**Report No. 10CFR21-0095**

**10CFR21 REPORTING OF DEFECTS  
AND NON-COMPLIANCE**

COMPONENT: Ingersoll-Rand series 89 air start motors  
P/N 8367694-ESI

SYSTEM: Emergency Diesel Generator – air starting system

**AIR START MOTOR CROSS-SECTION**

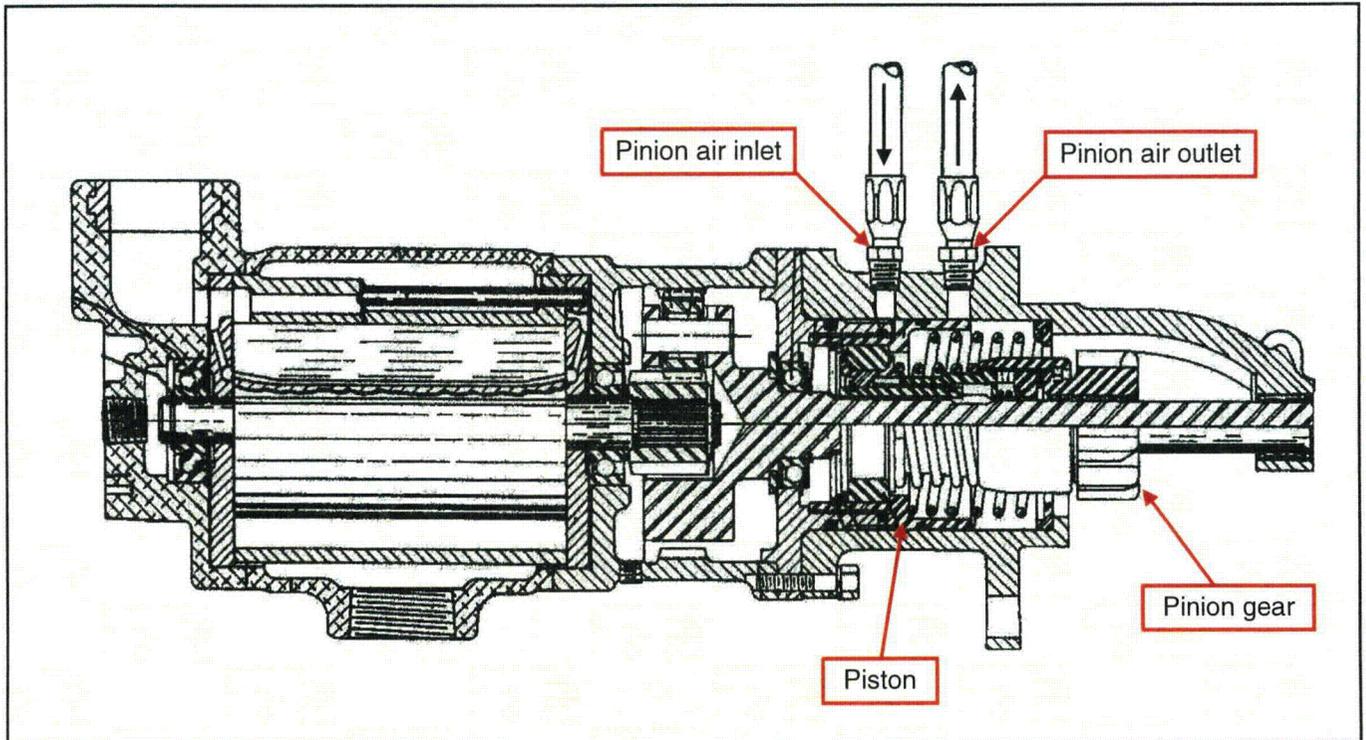
ESI inspection determined that Ingersoll-Rand used the wrong pinion engagement piston during assembly of the air motors. A new style piston with an elastomer seal ring (used in I-R's series 88 air starters) was incorrectly installed in the drive housing instead of the required piston with a metallic seal ring (required for the series 89 motor).

Installation of the elastomer seal and piston within the series 89 starter could impact starting reliability of the diesel engine for the following reasons:

- (1) the elastomer seal is located further away from the drive gear on the piston; this requires increased travel of the piston to port air from the pinion outlet port. During abutment of the starter drive gear with the engine ring gear, air will not port from the starter to activate the main air start valve and thus engine cranking will not occur.
- (2) the elastomer seal can be cut by the pinion outlet port hole in the starter drive housing after a number of starter engagements. This could cause binding of the piston within the drive housing and or excessive air leakage past the seal. Both conditions could increase the time required for the pinion to engage with the engine flywheel and thus compromise the fast start capability of the engine.

**INSPECTION PROCEDURE (OPTIONAL):**

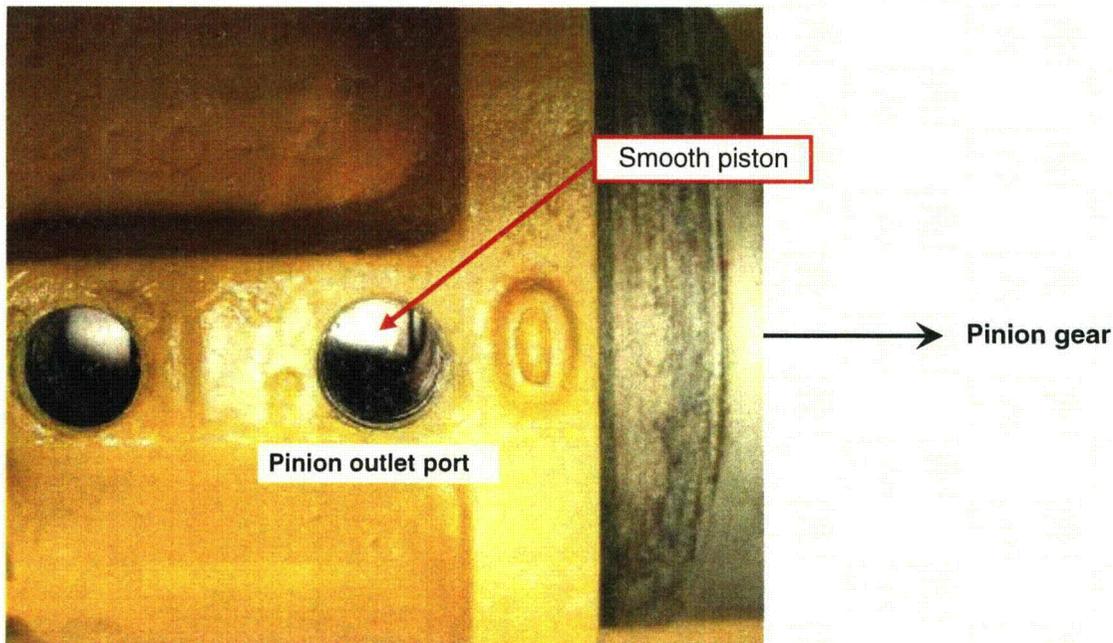
The pinion piston can be viewed through the pinion air outlet port to determine proper configuration. Refer to photos below.

1. ESI has contacted all affected customers that were shipped the incorrectly assembled starters. All starters have been returned to ESI.
2. ESI has added verification of correct pinion piston and seal assembly to the critical characteristic inspection activity for future starter shipments.
3. If desired, users can inspect other starters in their inventory to verify correct assembly of the pinion piston and seal. An inspection procedure is provided on the following page.
